ARBORIST REPORT
for
WW Sustainable LLC
4657 86th Ave SE
Mercer Island, WA

October 10, 2022
UPDATED MARCH 17, 2023

To: Cam Weaver
Company: Weaver Construction Co.
From: Benjamin Mark – Salish Restoration Associates
Date: 3/21/23
Re: Planned Excavation Within Driplines of Retained Trees

Root Disturbance Memo

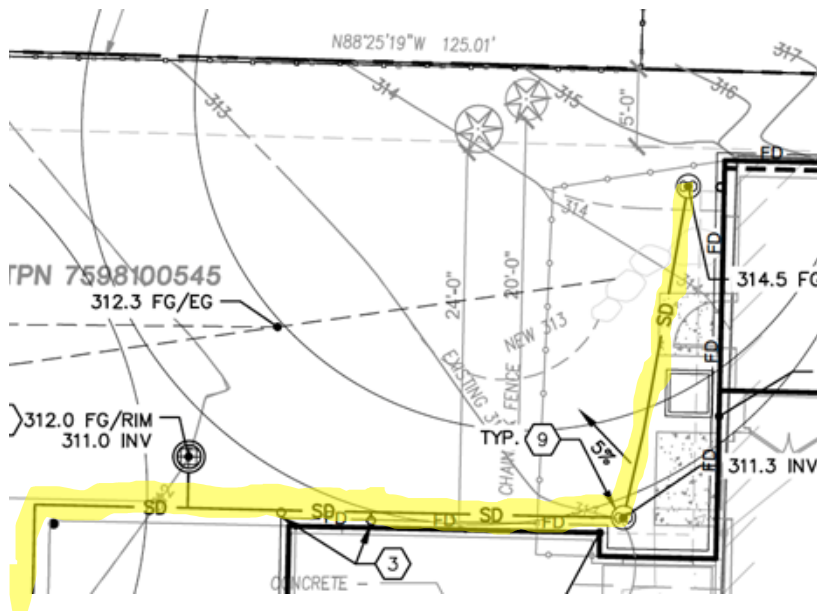
The Planning Department comments dated Feb 16th, 2023 included the following from City Arborist John Kenney:

1. Trees 4,5, 9,10 are exceptional and must be protected and not damaged. Tree protection is only 3' away from tree 10 which would damage the tree. Either move the proposed ADU, decks, buried power, all grading and SD utility line away from these trees. Any encroachment into these trees' dripline must show the trees will not be damaged according to MICC19.10.080. Or advanced root analysis by air excavation with arborist monitoring and follow up analysis required. The arborist will determine the limits of allowable disturbance for the trees where tree protection fence will be placed and not moved. At least 5 feet of space between the building and the fence is required to construct the home without entering the tree protection zone. Arborist must review and cite the civil and site plans. Or if trees cannot be retained and undamaged, they must be justified for removal under MICC19.10.060(A)(3).

The northwest corner of the existing house is within the dripline of Tree #10, approximately 12 feet from the trunk. If a minimum of five feet of space between the building and the tree protection fence is required, this will significantly reduce the area of undisturbed grade within the trees' critical root zone. Any encroachment into these trees' dripline must show the trees will not be damaged according to MICC19.10.080.

The current site plan shows a storm drain trench is planned to be installed within the shared drip line of Trees #9 and #10 west of the existing home's footprint. The route of this storm drain is within the required five-foot space between the existing building footprint and the tree protection fence.

Determining the size and number of roots that will be encountered during the installation of the storm drain requires an advanced root analysis by air excavation (Air-spade).

Air excavation of the drainage path will allow the project arborist to assess the potential impacts to trees #9 or #10 and potentially allow for installation of the storm drain below significant structural roots without cutting them.

If all structural roots over three-inches in diameter can be preserved, the tree's structural integrity is unlikely to be affected, but some decline in vigor may be seen in the future due to loss of roots within the 'Critical Root Zone' (CRZ) of these trees.

- Excavate the drainage path within the drip lines with an air-spade to allow the project arborist to assess the roots in the trench. If possible, install the drainage pipe below the structural roots without cutting them. Following excavation, supply supplemental irrigation to the trees until the fill can be replaced.
